CONTRACT NO. DE-AC27-01RV14136 – TRANSMITTAL OF U.S. DEPARTMENT OF ENERGY, OFFICE OF RIVER PROTECTION (ORP) DESIGN OVERSIGHT REPORT ON HIGH LEVEL WASTE (HLW) VITRIFICATION FACILITY TREATMENT CAPACITY, D-04-DESIGN-008

**Waste Treatment Plant
HLW Vitrification Facility Treatment Capacity**

D-04-DESIGN-008

Figure 1 Summary of Design Capacities, Design Margin and Capacity Enhancements Needed for Each of the Major process and Mechanical Systems in the HLW Vitrification Facility to support a 7.5 MTG/d Production Rate

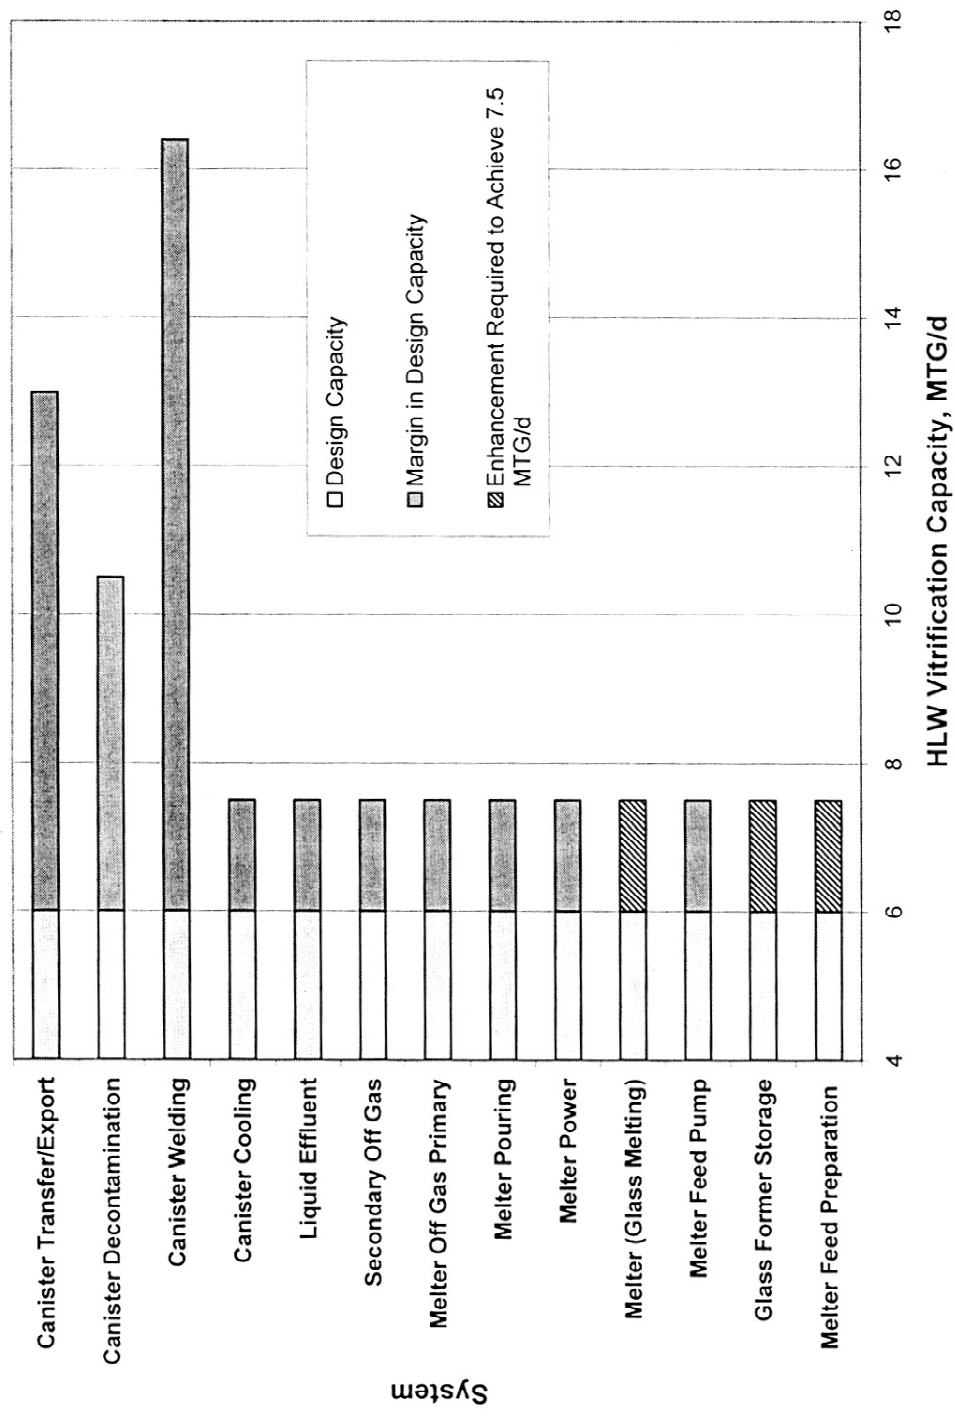
Figure 1 illustrates the magnitude of the design capacities; design margin and capacity enhancements needed for each of the major process and mechanical systems in the HLW Vitrification facility to support a 7.5 MTG/d production rate.

Figure 2 Canister Handling Schematic

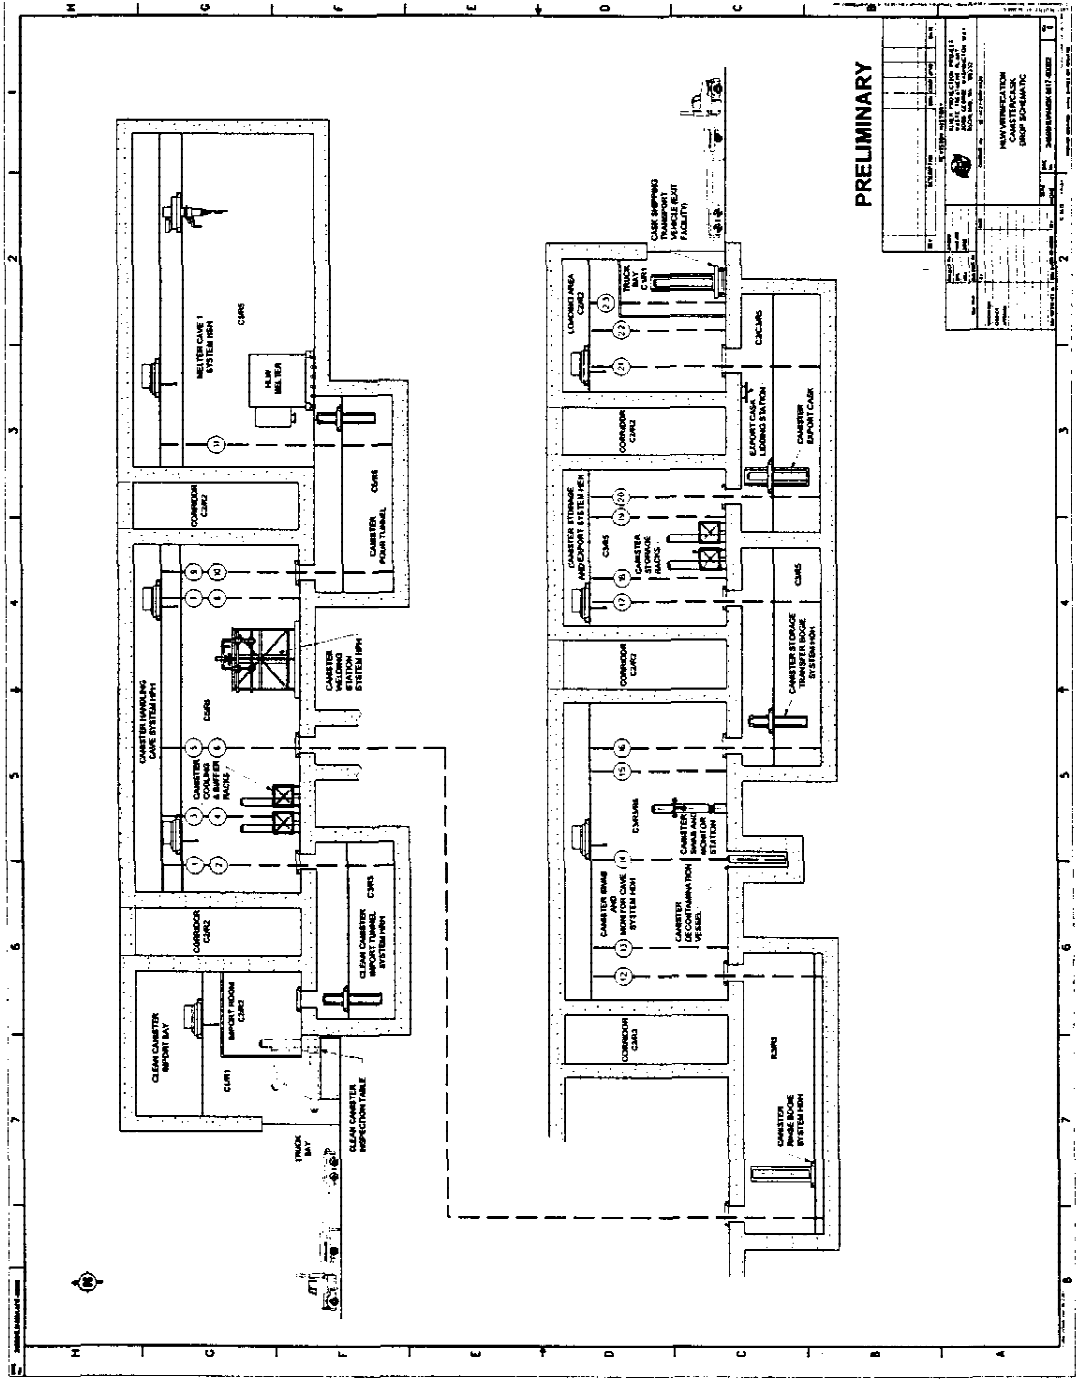
- Neither BNI Systems Engineering nor BNI Design Engineering have completed reviews of the model input data or its configuration. Considering the critical role of this model in confirming the functionality of the plant, Systems and Design Engineering should have a more active role in confirming the veracity of the modeling.

- The model does not appear to include the buffer rack in the Canister Handling Cave. It should be determined if the model includes the Canister Buffer Rack and, if it does not, provide justification for not including this rack in the model.

- This model is a valuable tool for confirming the functionality of plant systems and identifying potential pinch points in plant throughput. This model should be kept up-to-date through plant cold and hot commissioning and be turned over to the operating contractor for use as a training and design modification tool during plant operation.

Open Item 8: ORP should conduct an additional detailed design oversight on the Operational Research Model used to estimate plant availability to further evaluate the issues identified in the HLW Vitrification facility design oversight. The scope of this oversight should include all major WTP facilities.

Figure 3 Summary of Design Capacities, Design Margin and Capacity Enhancements Needed for Each of the Major process and Mechanical Systems in the HLW Vitrification Facility to support a 7.5 MTG/d Production Rate

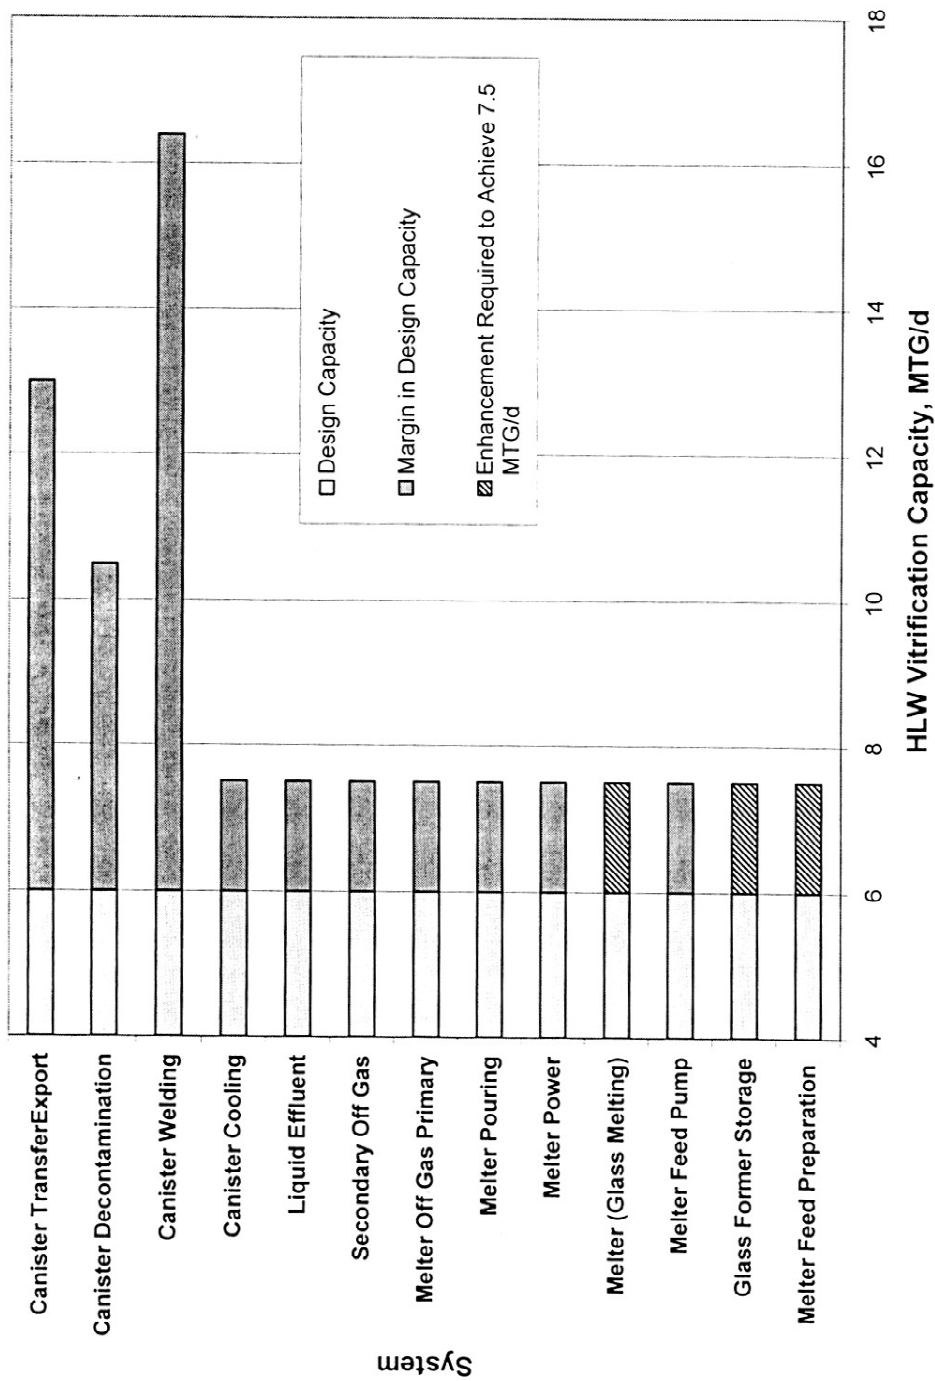
The information collected and developed as part of the design oversight can be used to estimate the design capability of the HLW Vitrification facility. This information is summarized in Table 1 below and in Figure 3.

Figure 3.1 illustrates the magnitude of the design capacities; design margin and capacity enhancements needed for each of the major process and mechanical systems in the HLW Vitrification facility to support a 7.5 MTG/d production rate.

Several of the mechanical handling systems (Canister Import/Export, Canister Decontamination and Canister Welding) have design capacities, which when considering design margins, are significantly greater than minimum requirements. This is primarily a result of the capability of mechanical systems which are infrequently used but essential to plant operations. There are no significant opportunities to reduce capability of these mechanical systems to reduce capital cost of the HLW vitrification facility.

Figure A.2 Pretreatment Solids Loading, Glass Waste Loading and Glass Yield Relationships

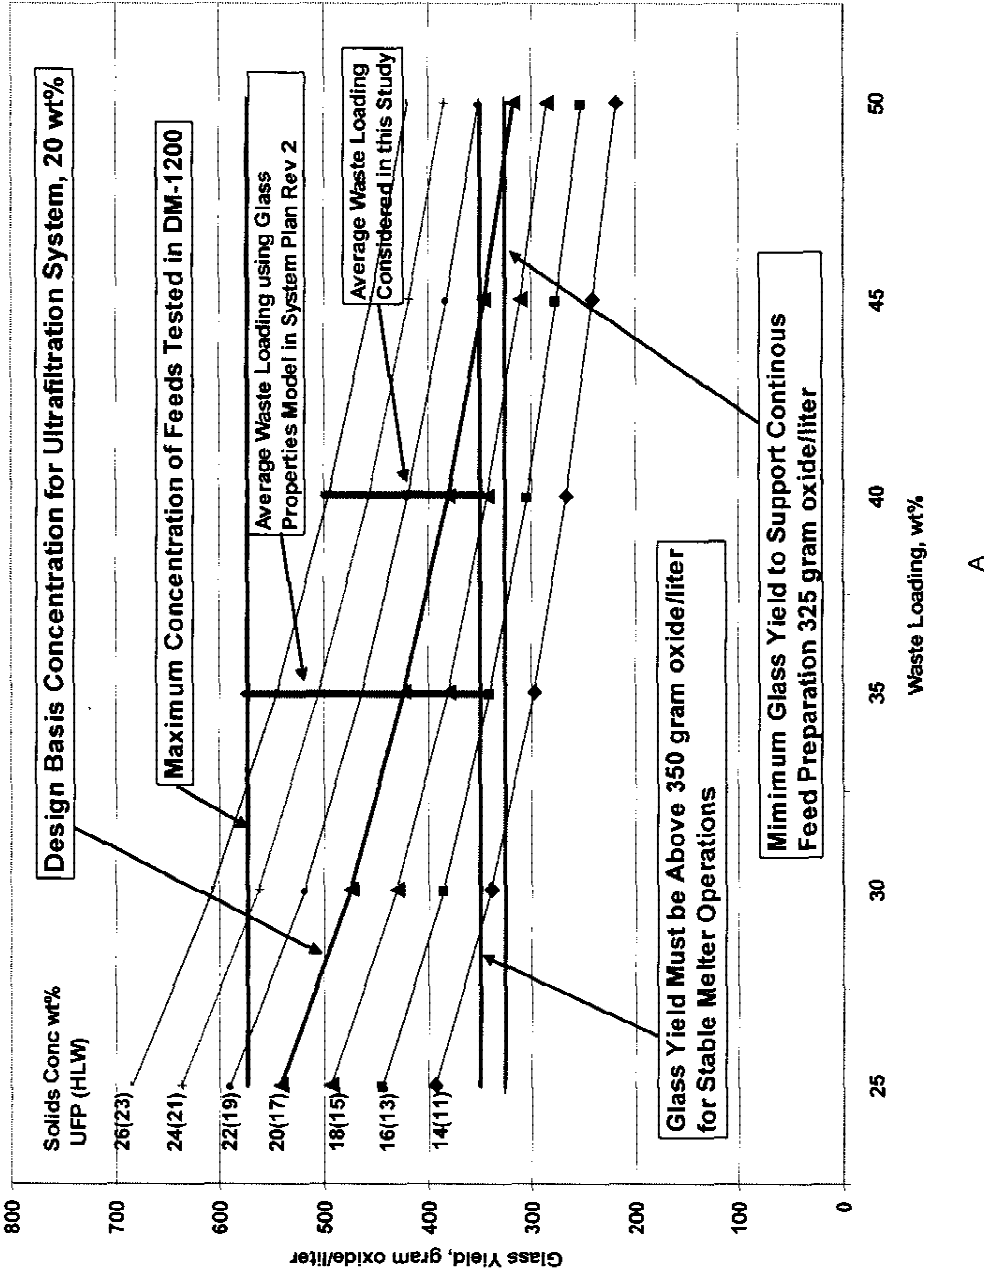
BNI calculations (24590-HLW-M4C-HFP-00002, 24590-HLW-M4C-HFP-00003) and DM-1200 melter testing information can be used to estimate the minimum solids concentration from the Pretreatment facility to achieve the HLW melter design capacity of 3 MTG/d/melter. (This is done because this work has not been completed by BNI.) Figure A.2 shows graphically information obtained from parametric calculations (24590-HLW-M4C-HFP-00002, 24590-HLW-M4C-HFP-00003) that can be used to relate glass yield per liter of melter feed to waste oxide loading in the glass at various solids concentration generated in the Ultra-filtration system. This figure also has minimum glass yield concentrations identified. A minimum glass yield of 350 gram oxide/liter corresponds to the minimum concentration to allow the HLW melter to operate with a stable cold cap (personal communication with JM Perez of BNI-WGI, November 17, 2004). Based upon recent DM-1200 melter tests at the Vitreous State Laboratory (VSL) it was determined that at feed rates scaled to the 3 MTG/d WTP melter the glass yield needed to be greater than 350 gram oxide/liter to maintain stable melting and consistent melter plenum temperatures. In addition, a minimum concentration of 325 gram oxide/liter is noted based upon the assessment of the capacity of the HLW feed preparation system (24590-HLW-ES-PR-04-0001). Below 325 gram oxide/liter HLW melter feed cannot be prepared in sufficient time to maintain continuous melter operations at 3 MTG/d/melter.

Figure A.2. can also be used to determine the minimum acceptable HLW solids concentrations from the Pretreatment facility. Assuming that the HLW solids are diluted with waste by a total of 3 wt%, and the glass waste loading is 35 wt% waste oxide, then the minimum solids concentration from Pretreatment must be ~17wt% or greater. (This result should be confirmed during resolution of the design issues in the Pretreatment facility and in the preparation of a process-ability specification for the HLW Vitrification facility.)

The WTP Contract is based upon specific concentration values, identified in *Specification 1, Immobilized High-Level Waste*, that specify the minimum glass waste loading based upon chemical constituents of the waste. Based upon historical estimates, the average waste loading for the WTP Contract over the treatment mission would be about 28 wt%. ORP's System Plan (ORP-11242) is based upon the use of a Glass Properties Model as a means to project glass volume to estimate HLW glass loading. The System Plan estimates that the average glass waste loading would be about 35 wt% over the RPP mission. Over the RPP Mission, the glass loading assuming the Glass Properties Model is about 25% higher than the WTP Contract specifications. However, the case considered in this Design Oversight ("8000 in 2025") assumes that the waste loading is about 40 wt%. The increase in HLW glass waste loading requires that the solids concentration from the UFP System be increased.. This effect is illustrated in Figure A.2.

Figure A.3 Comparison of the Operating Day Capacity of the Glass Former Facility Chemical Hoppers Assuming Three Different Scenarios for the Determination of GFC Hopper capacity

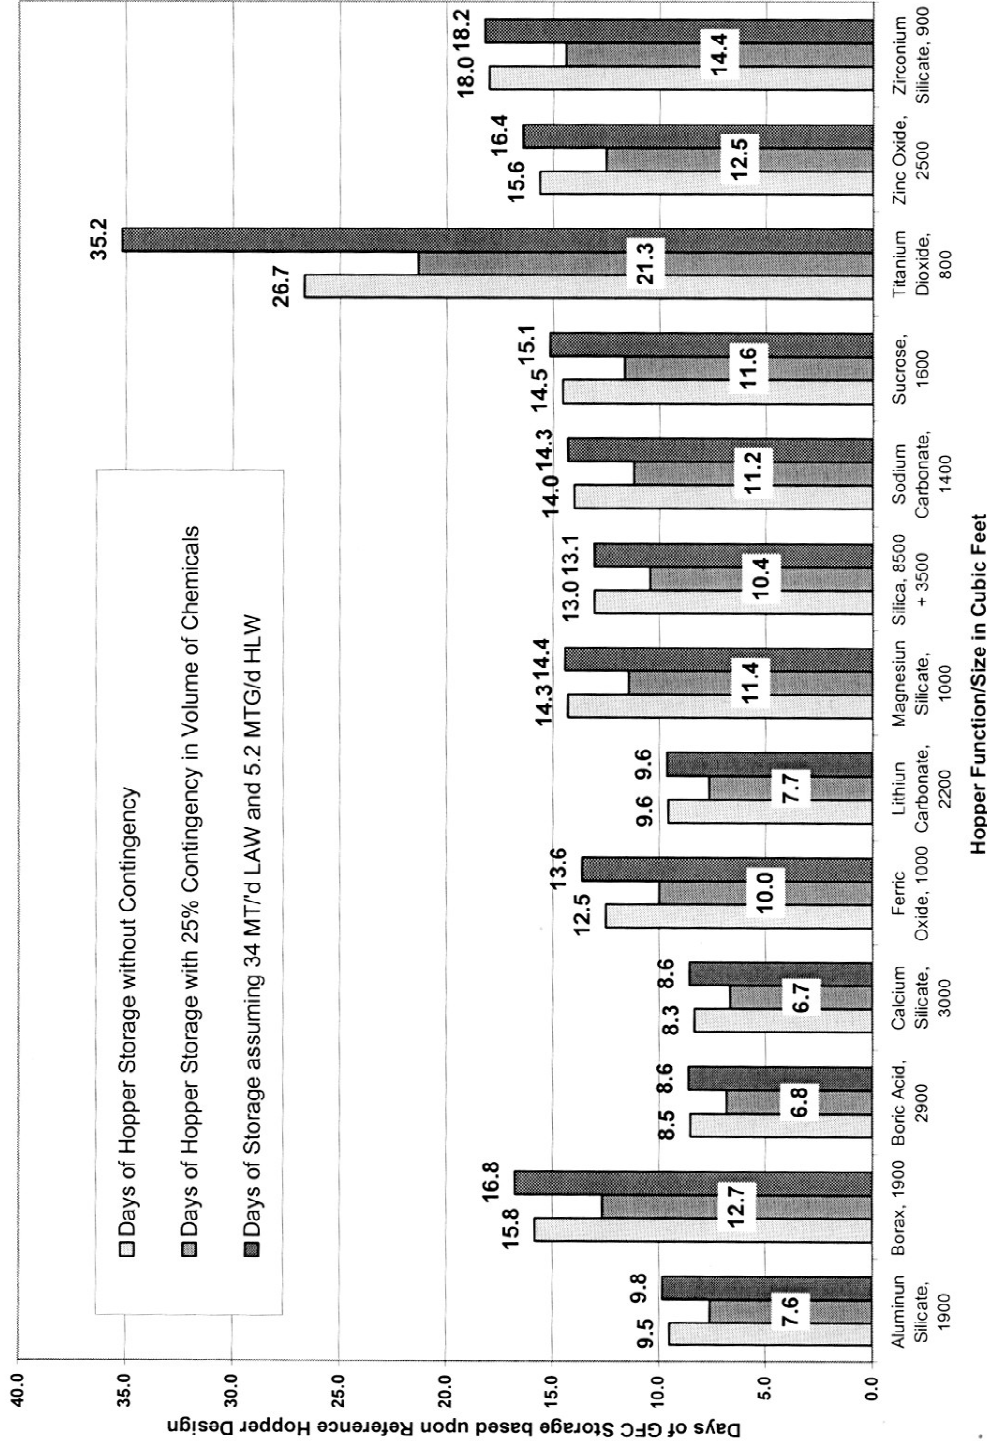
Figure A.3 shows the capacity in days of production for the 13 glass former batch sizes (translated into minimum hoppers capacity). Note that at the expanded capacity the silica would be contained in two hoppers having a size of 8500 and 3500 cubic feet. Three cases are presented in Figure A.3, these are the:

In all cases, there is at least one week of storage capability on the WTP Site for GFCs. This is assumed to be adequate based upon requirements to maintain continuous operations in the LAW and HLW Vitrification facilities. It is also assumed that in the expanded GFC system design that ORP will add a third blending hopper to support the preparation of the glass batches.

Figure B.1 HLW Glass Production Rate as a Function of Electrode Power

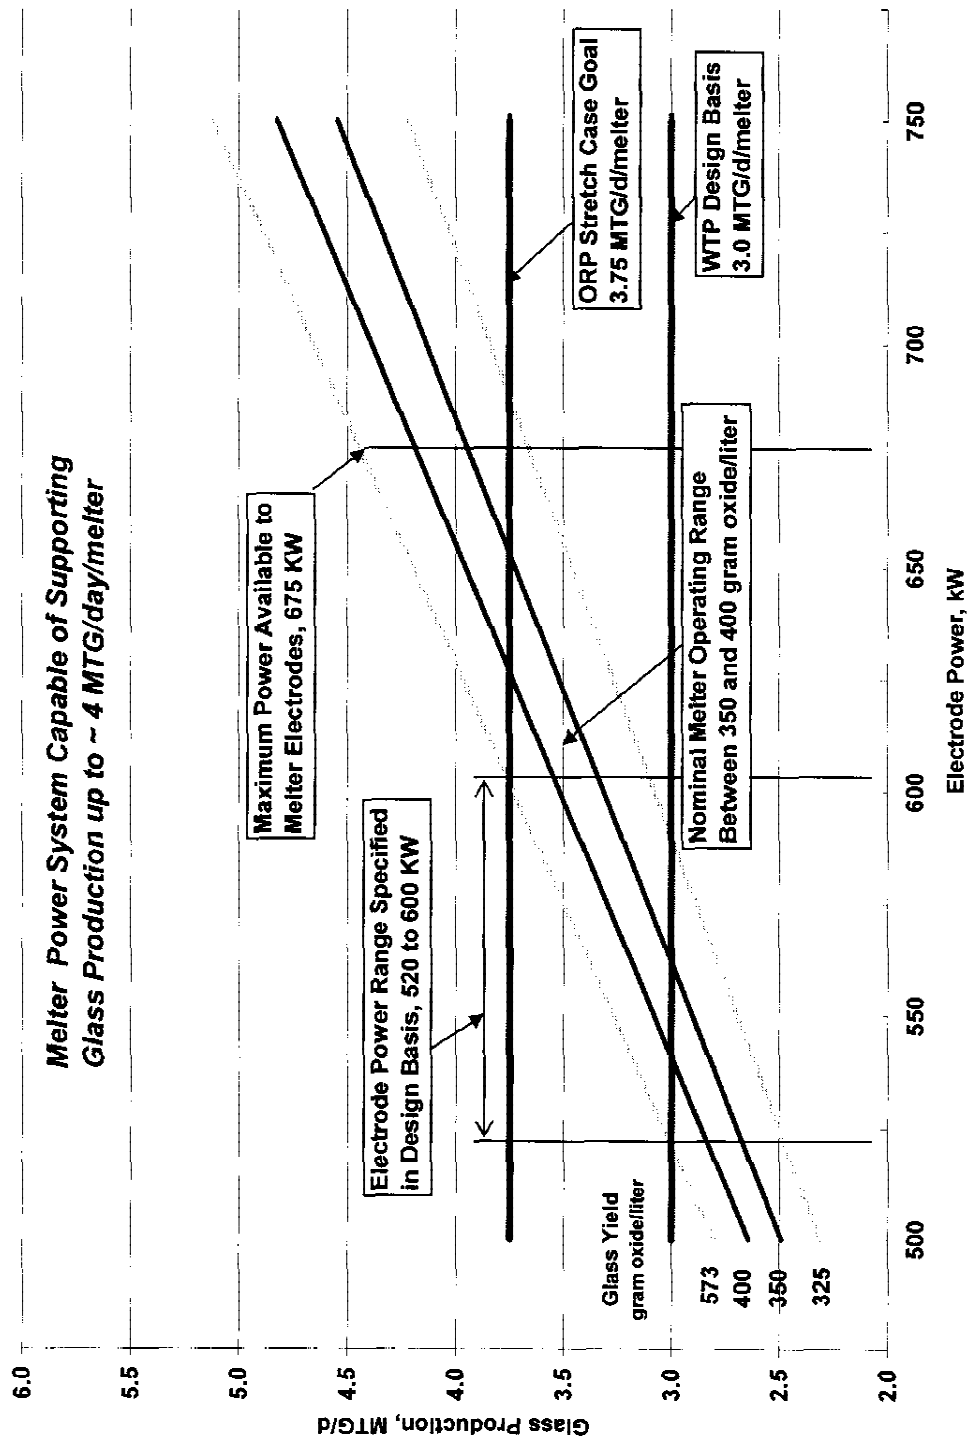
Figure B.1 presents HLW glass production as a function of electrode power based upon the equation above. This figure shows the relationship between melter glass production rate, electrode power and the glass yield in the HLW melter feed.

Figure B.1 also includes specific energy assumptions for four glass yield assumptions (325, 350, 400 and 573 gram oxide/liter of feed). Based upon the discussion provided in *Appendix A, HLW Melter Feed Preparation System*, the feed concentration should be above 350 gram oxide/liter to maintain stable melter operations. Concentrations of the waste feed above 450 to 500 gram oxide/liter may not be achievable when considering the design limitations of the Pretreatment facility ultra filtration system to prepare concentrated HLW solids concentrate.
